SUB-COMMITTEE ON  
RADIOCOMMUNICATIONS AND  
SEARCH AND RESCUE  
5th session  
Agenda item 14

COMSAR 5/14  
8 February 2001  
Original: ENGLISH

## REPORT TO THE MARITIME SAFETY COMMITTEE

Figure 4-7 – Computing drift speeds and directions from total water current and leeway

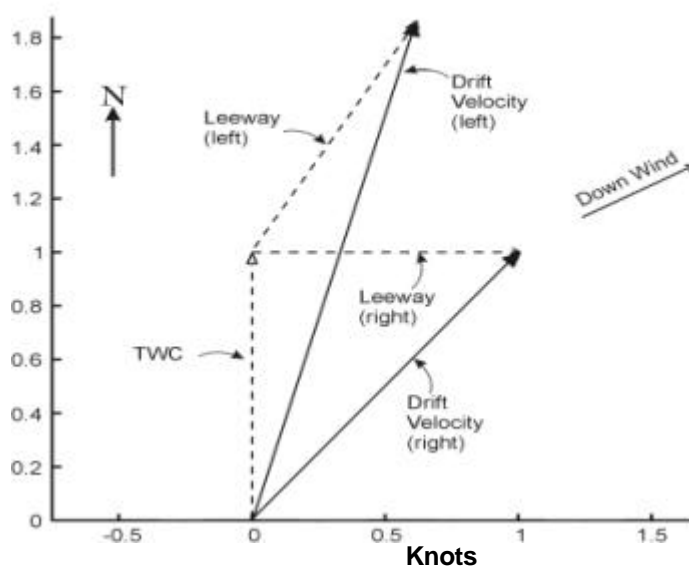
4-8	4.4.6	1	<b>From</b> “the direction and rate of drift” <b>to</b> “the directions and rates of drift”
4-8	Figure 4-7		<b>Replace</b> Figure 4 -7 with the one shown below.

Figure 4-8 – Determining new datums and divergence distance  
(drift distance = drift speed × time adrift)

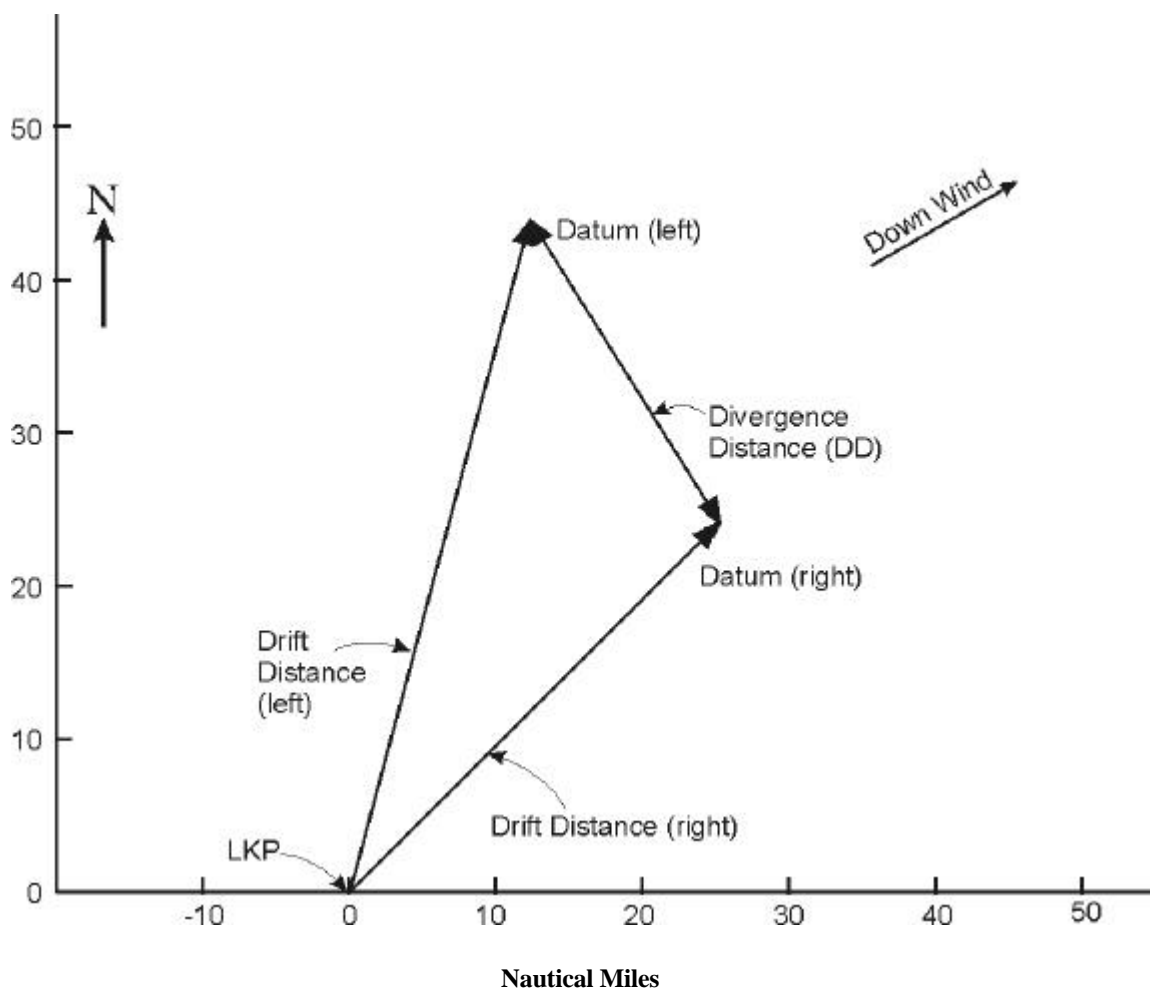
4-9 Figure 4-8 **Replace** Figure 4-8 with the one shown below.

Figure N-2 – Leeway of Life Rafts, Survival Craft and Persons in the Water (PIWs)

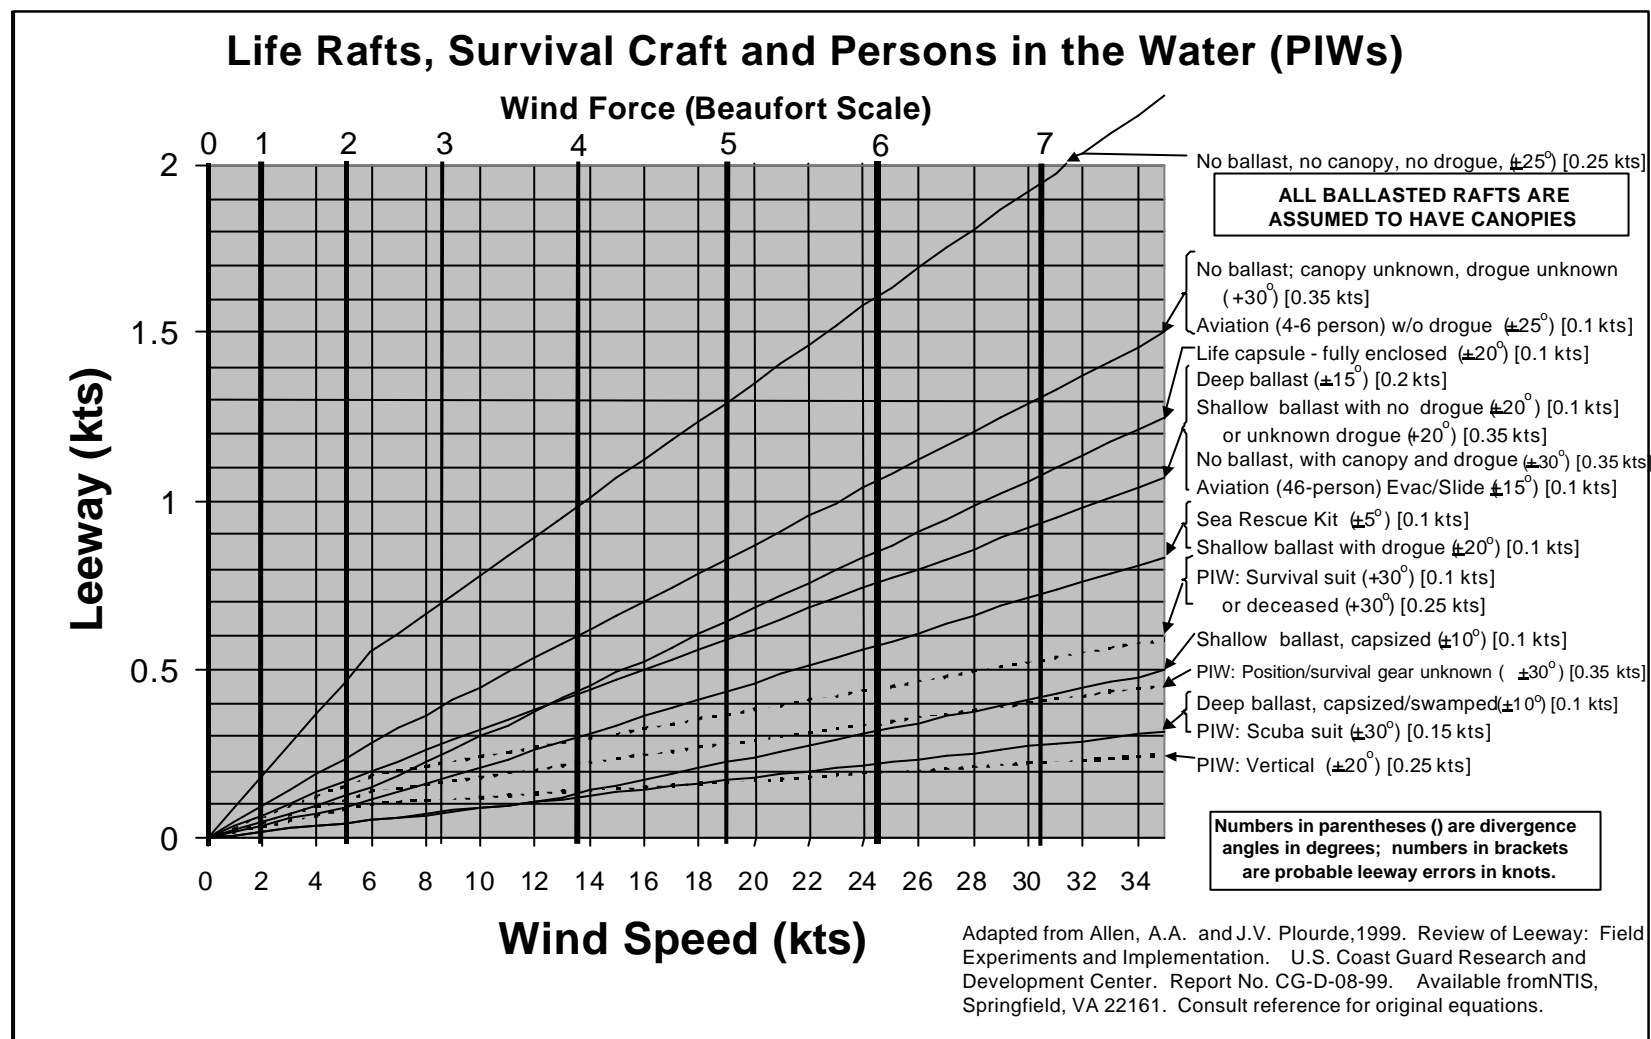
Page	Item	Line	Amendment
N-2	Figure N-2		<b>Replace</b> with attached Figure N-2 for “Life Rafts, Survival Craft and Persons in the Water.”
N-3	Figure N-3		<b>Replace</b> with attached Figure N-3 for “Power Vessels, Sailing Vessels and Person-powered Craft.”
N-4		2	<b>From</b> “of the distressed craft and the of the search facilities” <b>to</b> “of the distressed craft and of the search facilities” <i>i.e.</i> , delete the extra “the”.
N-6	Table N-5		<b>Replace</b> with attached “Table N-5 Sweep widths for helicopters (km (NM)).”
N-7	Table N-6		<b>Replace</b> with attached “Table N-6 Sweep widths for fixed-wing aircraft (km (NM)).”
	Table N-7		<b>Replace</b> with attached “Table N-7 Weather correction factors for all types of search facilities.”
	Table N-8		<b>Replace</b> with attached “Table N-8 Speed (velocity) correction factors for helicopter and fixed-wing aircraft search facilities.”
N-9	Table N-12	4000	In the second column under <b>Distance in nautical miles</b> , change value from “ <b>47</b> ” to “ <b>74</b> ”
